ADDENDUM NO. [1] Date: April 1, 2022

**RE: Physical Plant Renovation
 Western Technical College
 505 9th Street North
 La Crosse, Wisconsin
 HSR Project 21065**

**FROM: HSR Associates, Inc
 100 Milwaukee Street
 La Crosse, WI 54603
 (608) 784-1830**

A600

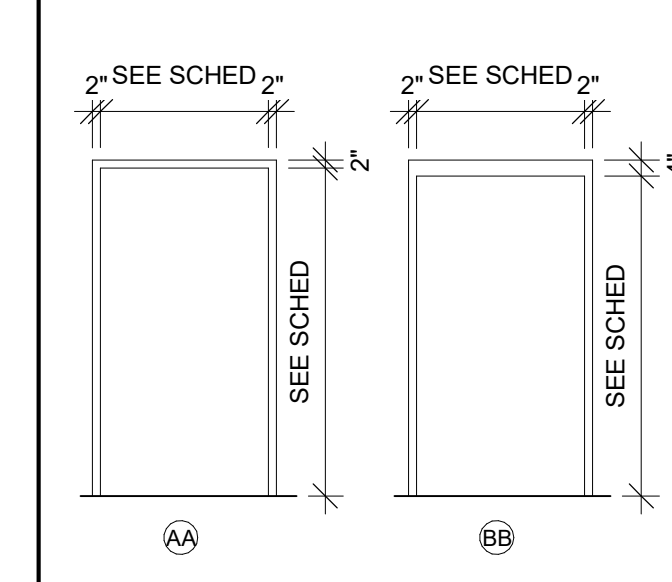
9. Sheet A600 WALL TYPES, DOOR SCHEDULE, SECTION
 - a. See 30"x42" sheet attached hereto.
 - b. Frame Elevations for doors 203.1, 203.2, and 204 updated. Frame details for door 202 updated.

4 Exterior Junction Box/wiring
NTS

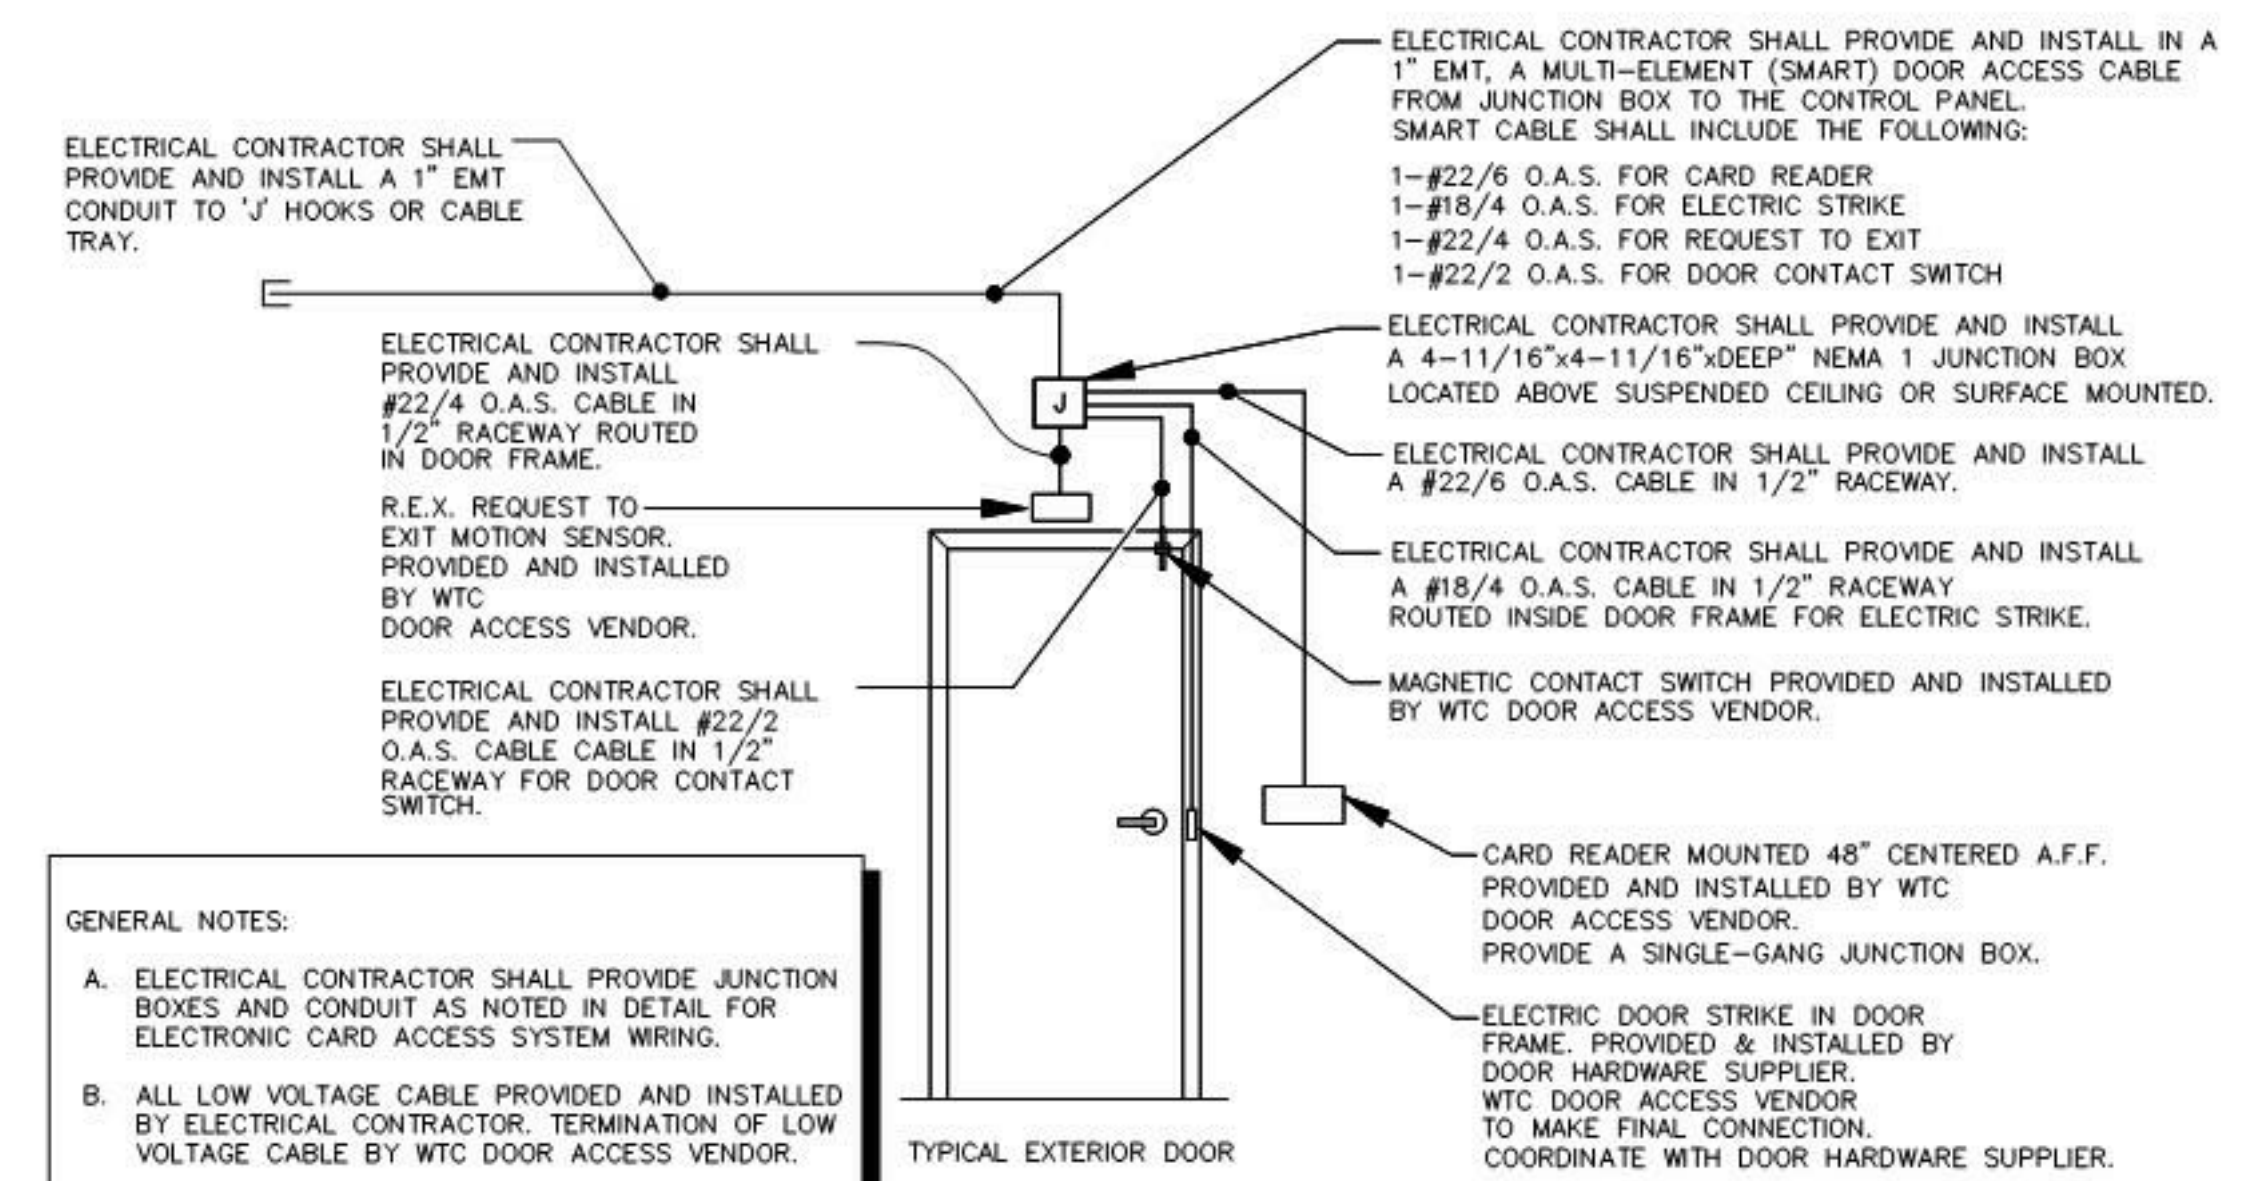
10. Sheet E090 – FIRST FLOOR ELEC. DEMO PLANS
 - a. See 30"x42" sheet attached hereto.
 - b. Added Exterior Junction box Wiring Detail 4E090.
 - c. Clarified removal and wiring at existing card readers.
 - d. Lobby 100: Salvage pendant light for reinstallation, and salvage door access controller.
 - e. Second floor demo plan: Added removal of junction box.
 - f. Add Detail 4E090 - Exterior Junction Box/wiring.

1 FIRST FLOOR POWER PLAN
 1/8" = 1'-0"

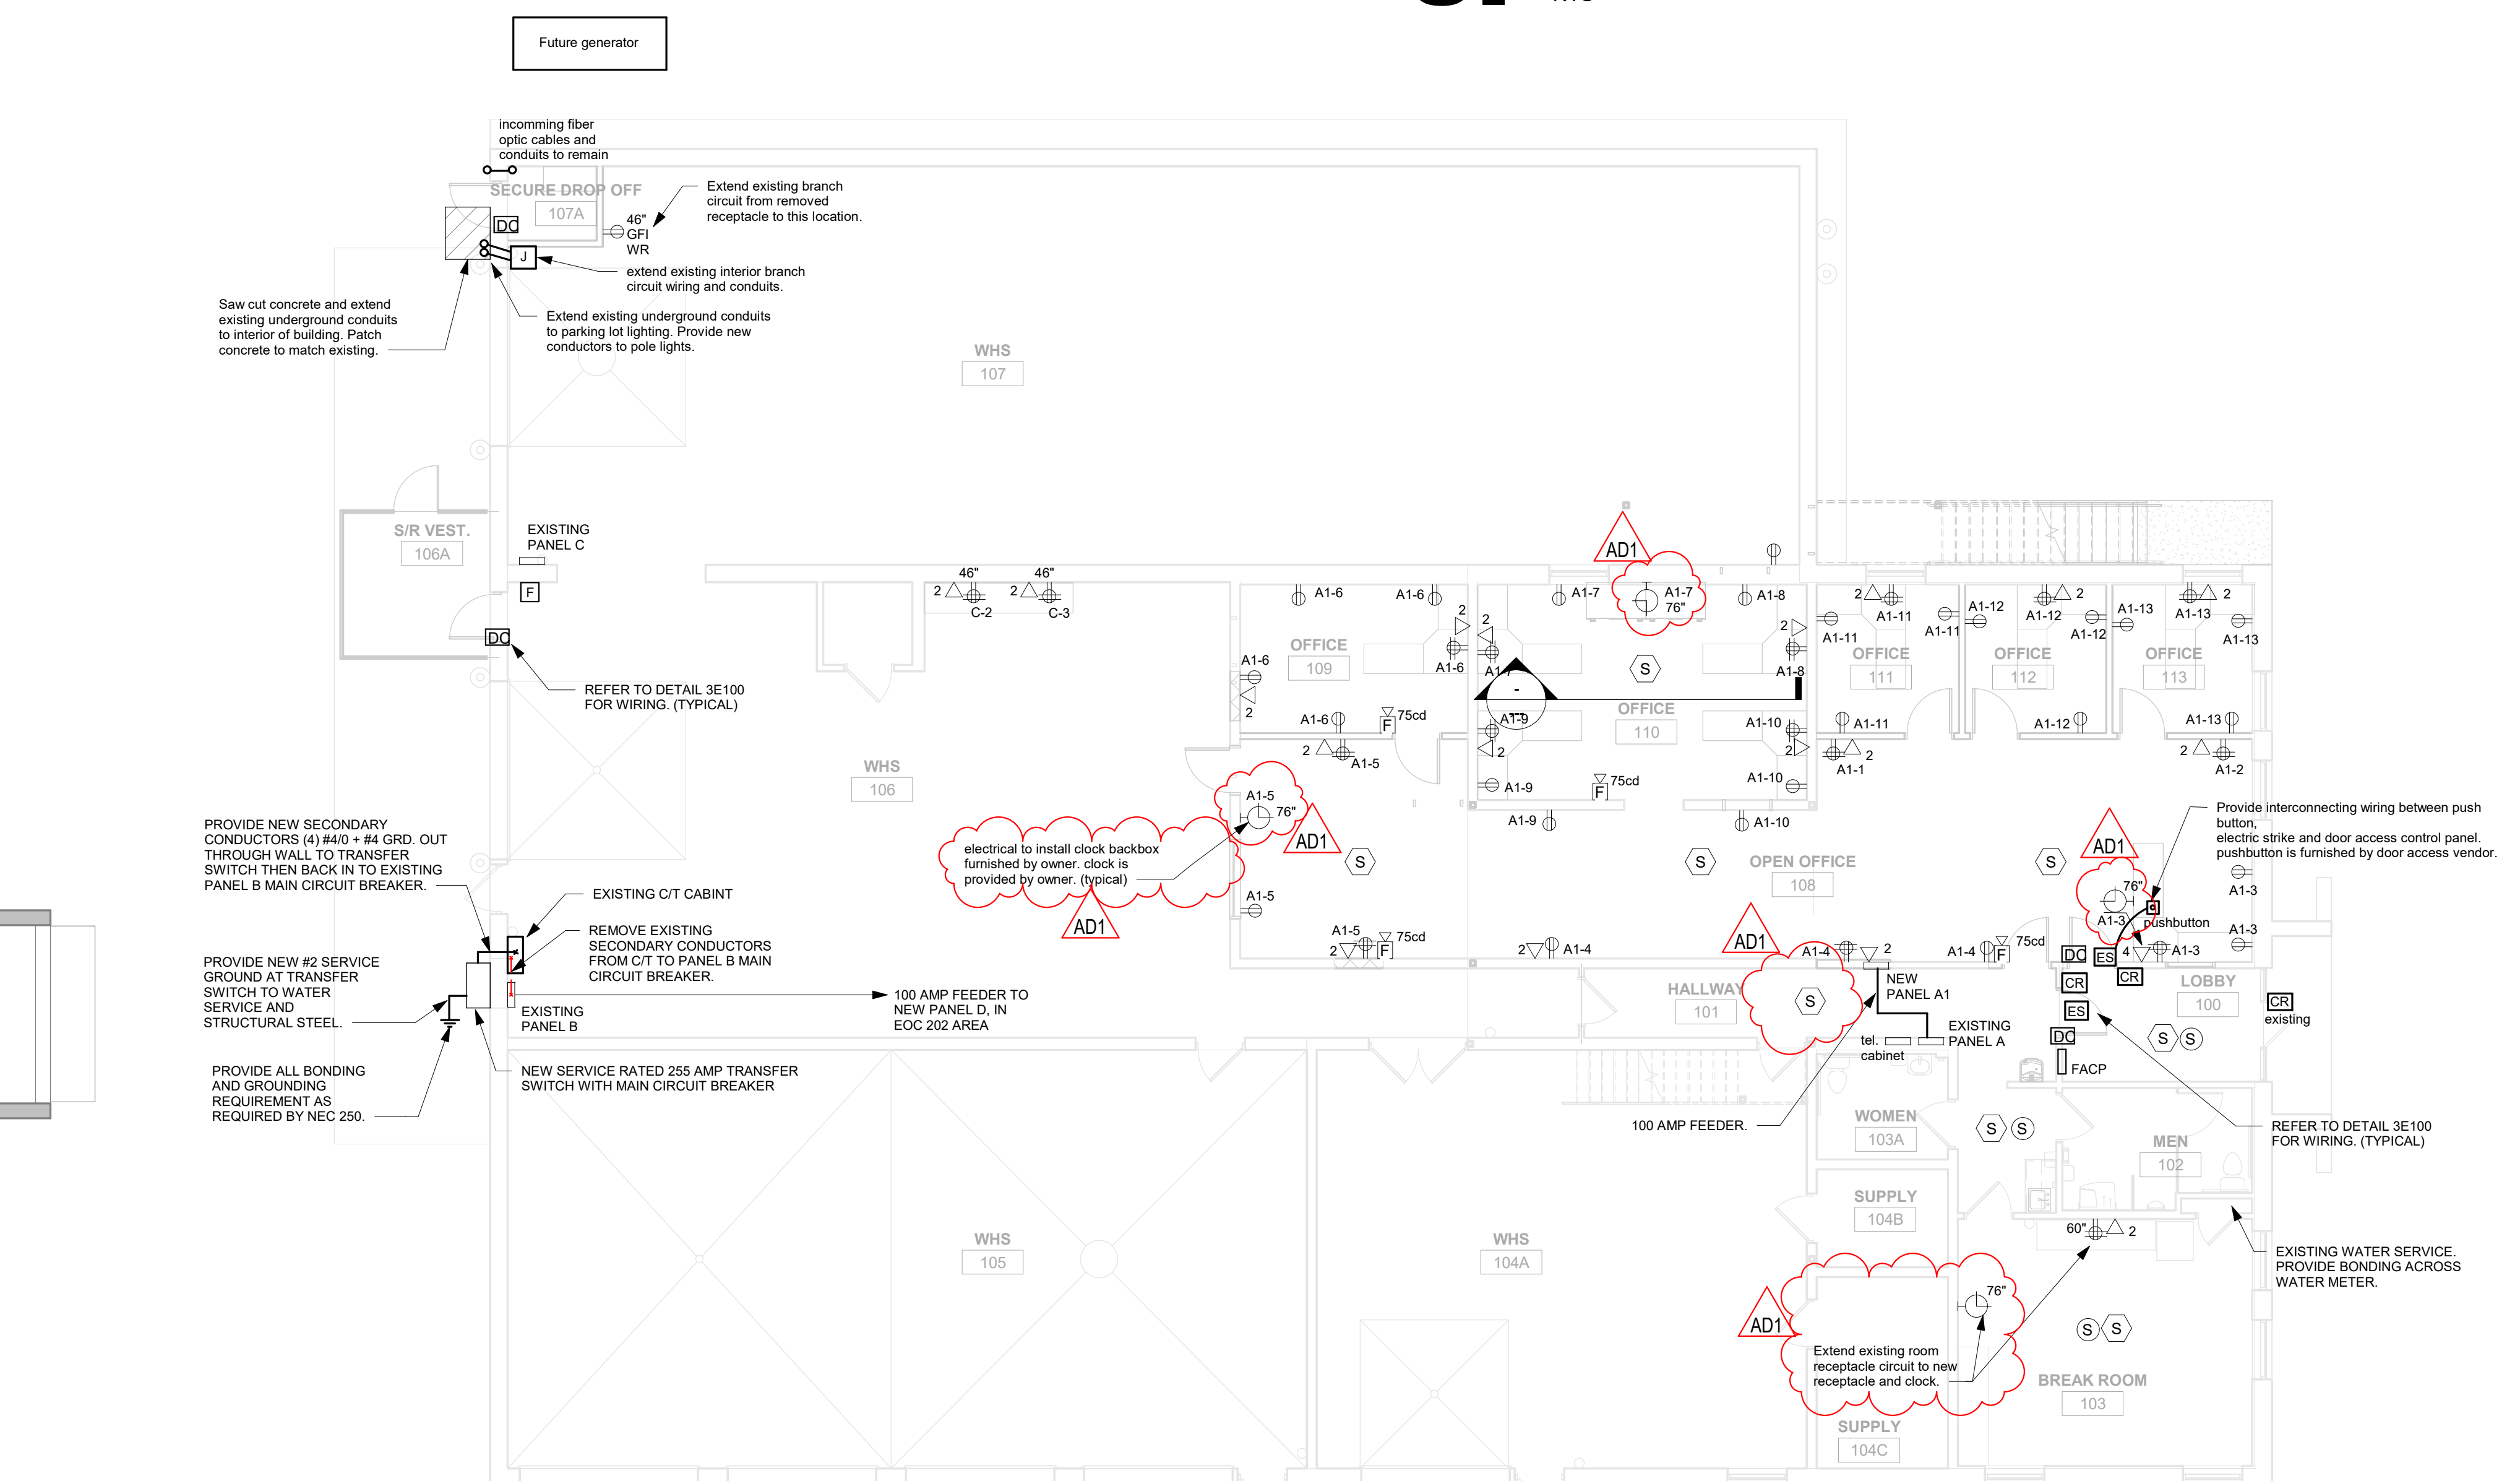
11. Sheet E100 – FIRST FLOOR POWER PLAN
 - a. See 30"x42" sheet attached hereto.
 - b. Hallway 101: Added Smoke detector.
 - c. Added clocks to the following rooms: Break room 103, Office 108 & 110.
 - d. Storage room 202: Added note about door access panel.
 - e. Room 203: added clock.

3 ROOM CONTROLLER 2 ZONE

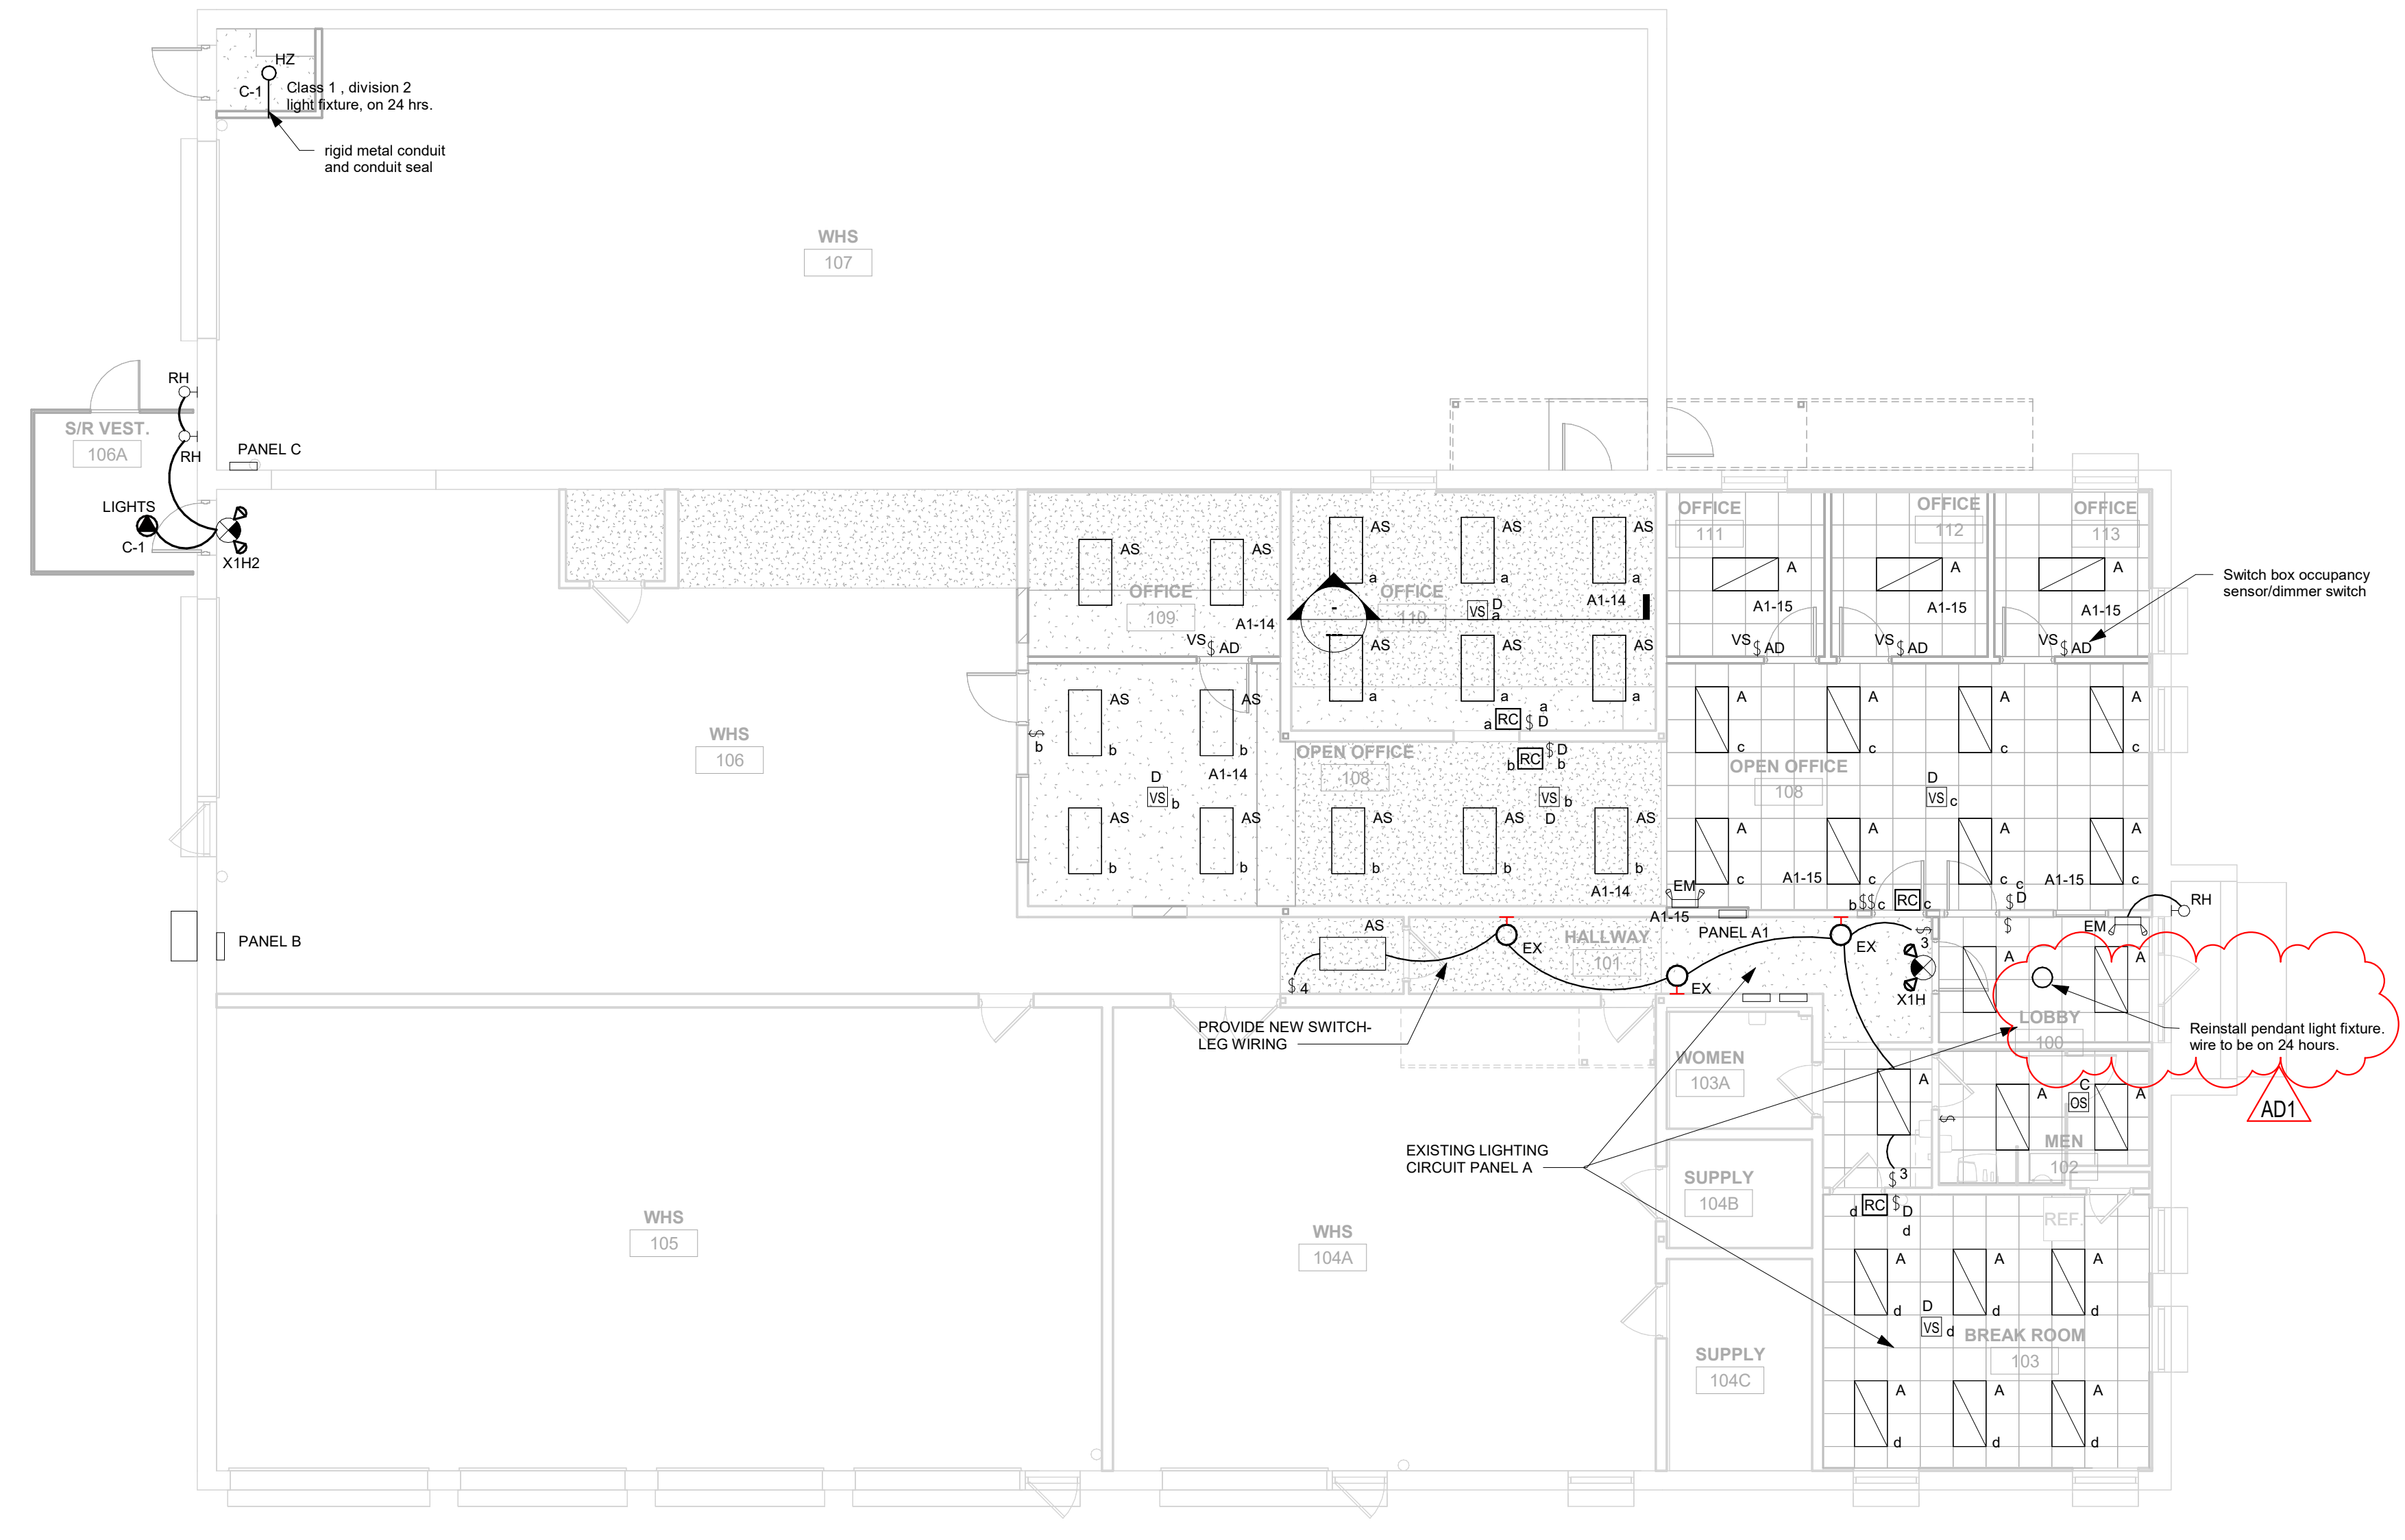
12. Sheet E200 – FIRST FLOOR LIGHTING PLAN
 - a. See 30"x42" sheet attached hereto.
 - b. Lobby 100: reinstall pendant light fixture.
 - c. Revise light fixture schedule.
 - d. Revise room controller detail.
